PRELIMINARY UNION ELECTRIC COMPANY
PEAK DEMAND PROJECTION

A REPORT TO THE CALLAWAY PROJECT TASK FORCE

PREPARED BY
PETER A. HAIGH

Figure 3

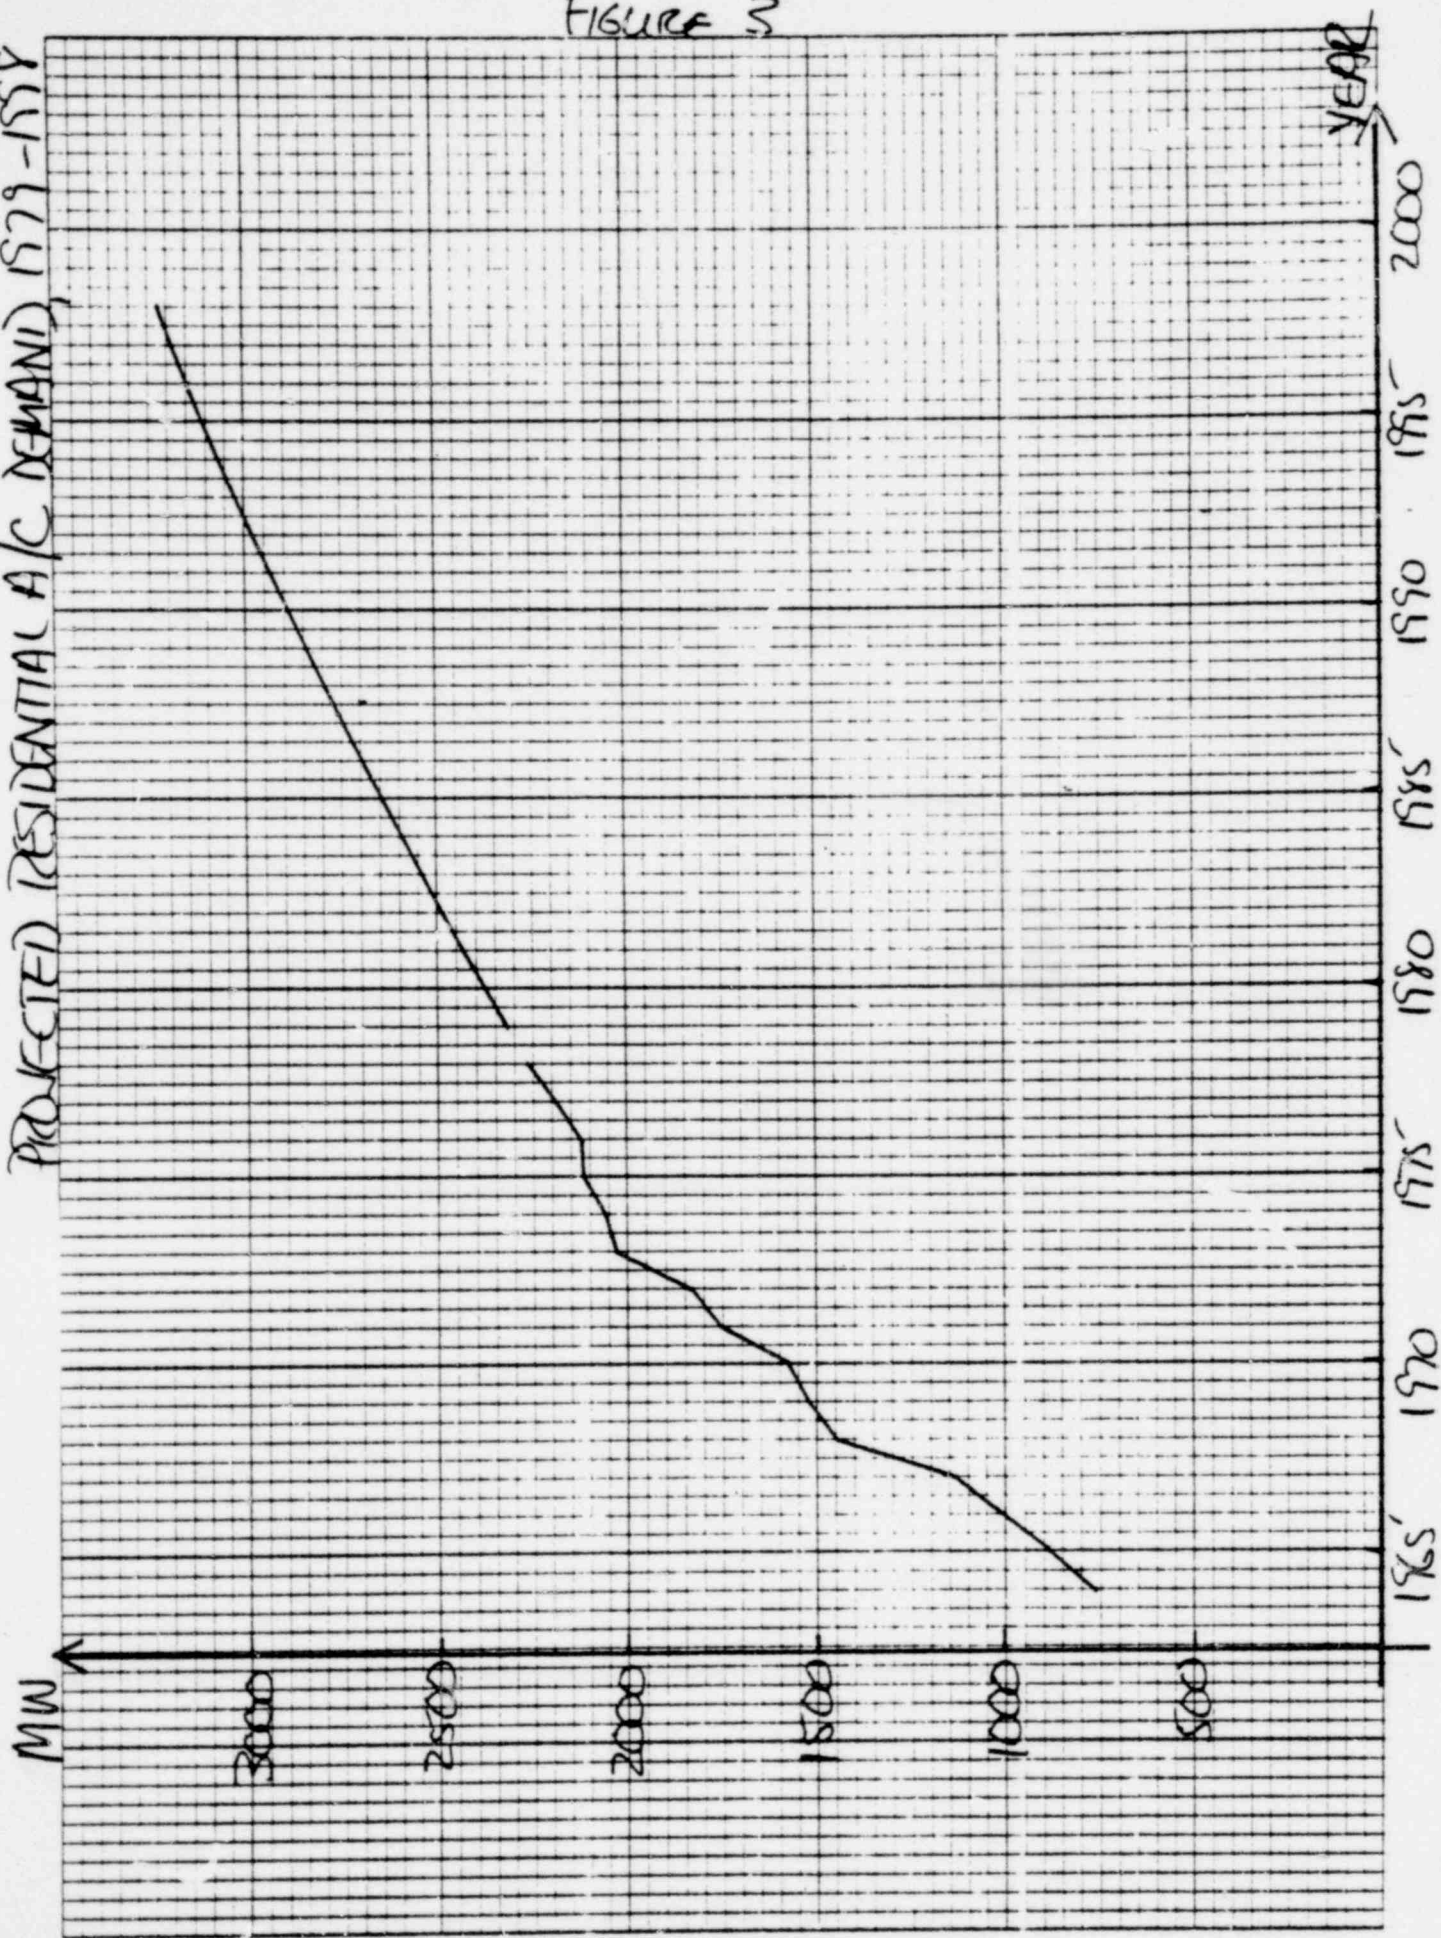
The model computer run can be found as Schedule 4 in the Appendix and the projections can be found graphically in Figure 3 and numerically in Table 7.

The UE model is somewhat unconventional and very difficult to interpret although its projections seem very reasonable compared to historical growth and no alternative model could be found, given the data which the Staff currently has, which provided projections as accurate and stable as UE's. However, the same caveat should

be made here as at the end of Section II. It is realized that much more research has to be done before a high degree of confidence can be placed on these results.

FIGURE 4

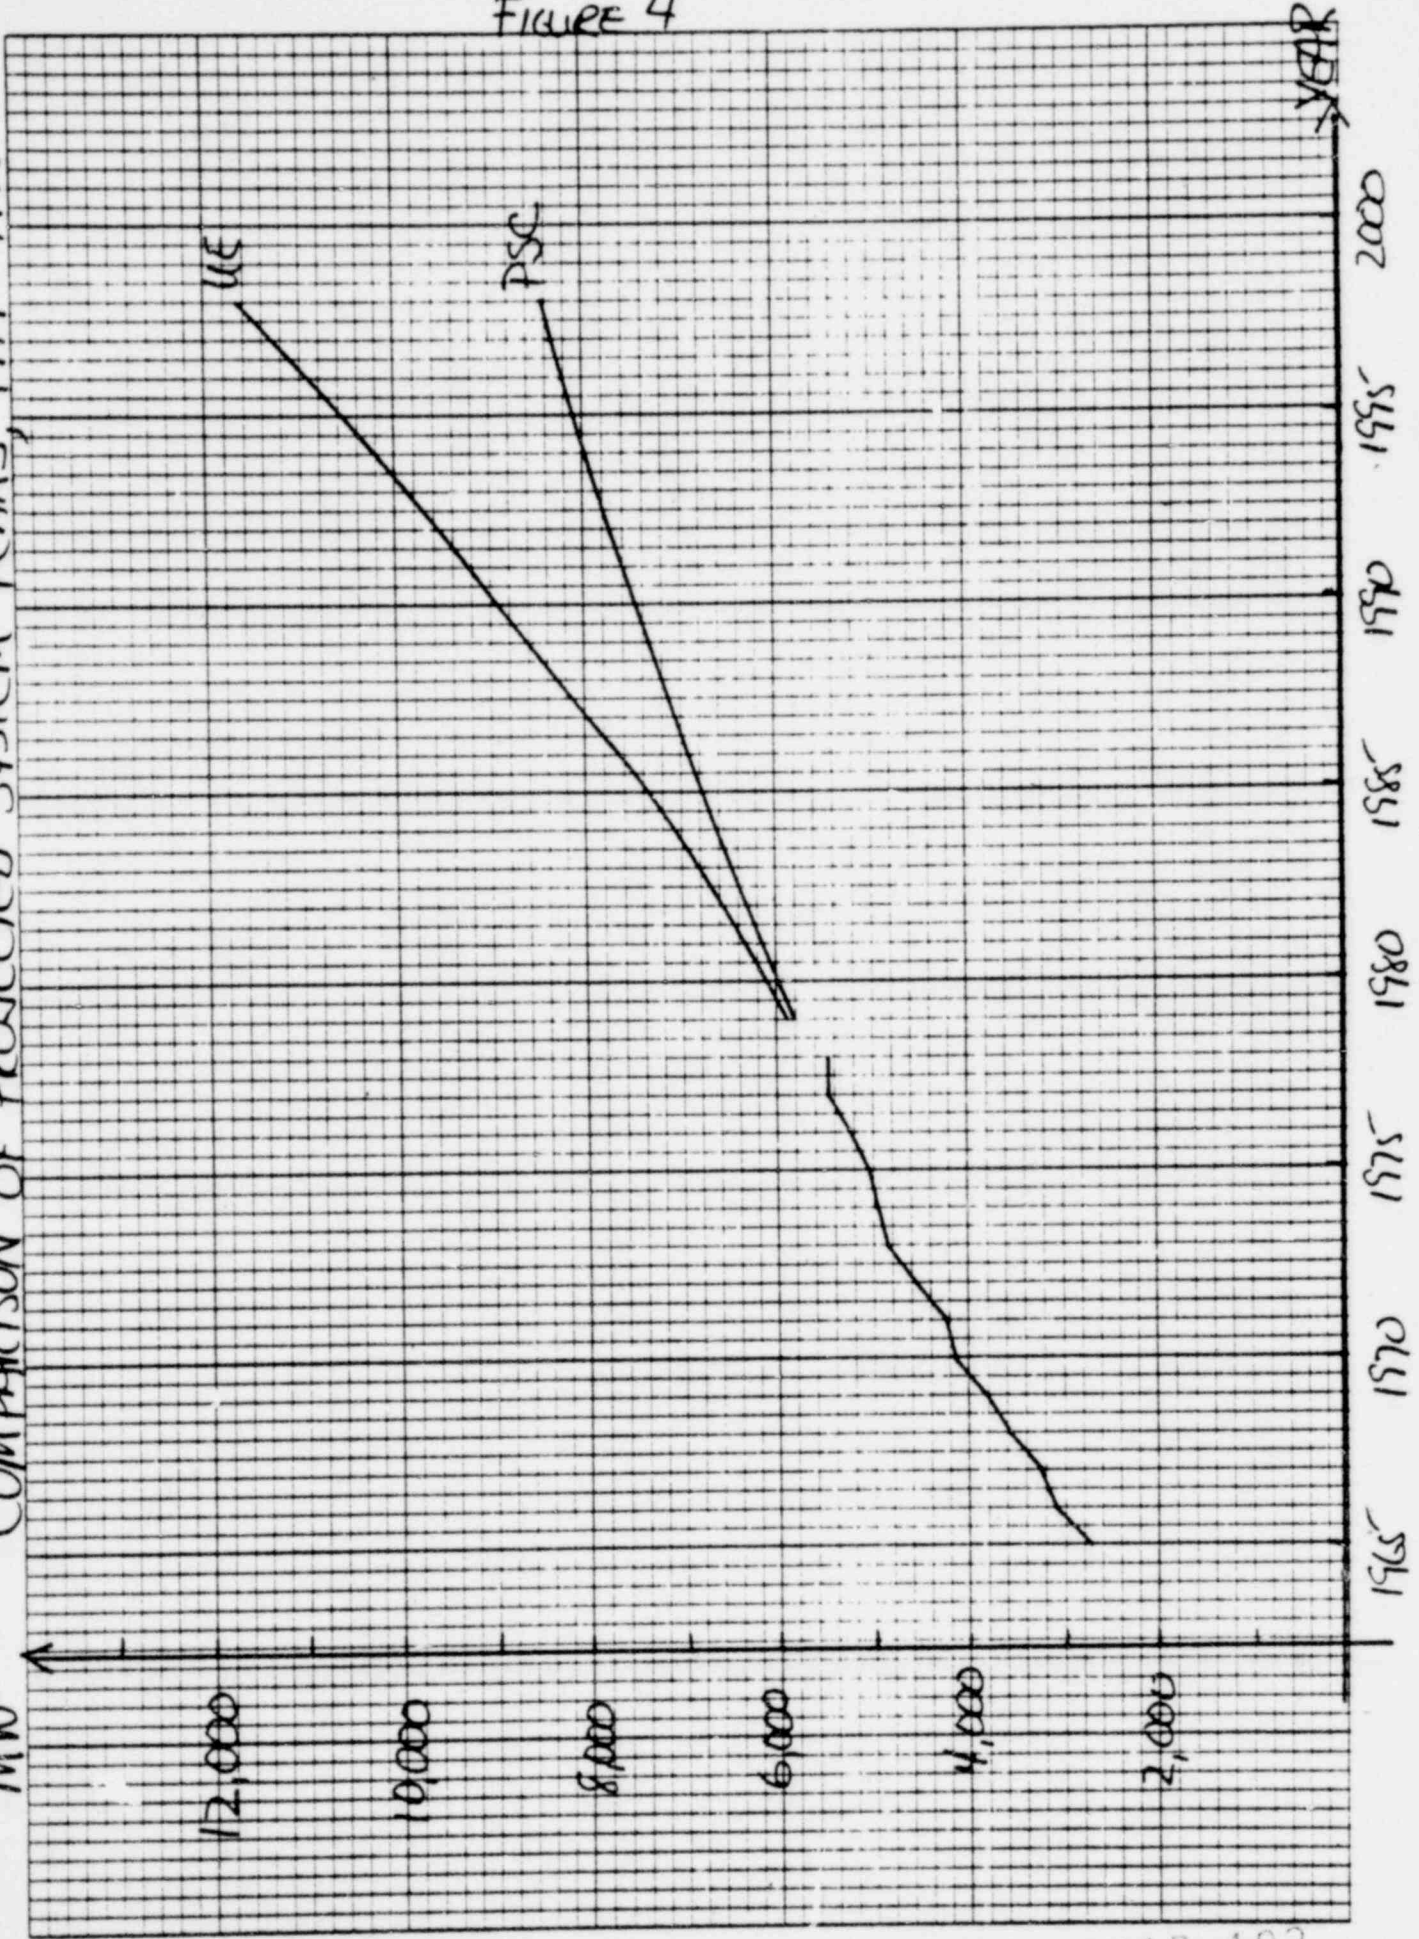
A comparison of projected system peak based on UE's and the Staff's models can be found graphically in Figure 4 and numerically in Table 10. Of particular interest is how these forecasts translate into capacity deficits if Callaway I is not brought on line. Tables 11 and 12 provide this information through 1988 based on the UE and Staff forecasts, respectively, including the 15% capacity reserve required by UE's power pool agreement.

The base load component is the major contributor to difference between UE's and the Staff's projections. UE's model does not seem consistent with the changes in electricity consumption which have occurred since the OPEC oil embargo. In fact, in November, 1977 UE forecast 1978 summer base to be 3040 while the actual value which occurred was 2933, a drop of 107 mw. The explanation given for this unexpected drop was the coal strike in early 1978 which caused a downward shift in consumption due to user adjustment to the conservation required during the strike. This was similar in type to the effect of the OPEC oil embargo. The unstable energy supply situation we are currently experiencing testifies to the possibility of recurring "conservation effects" in the future.
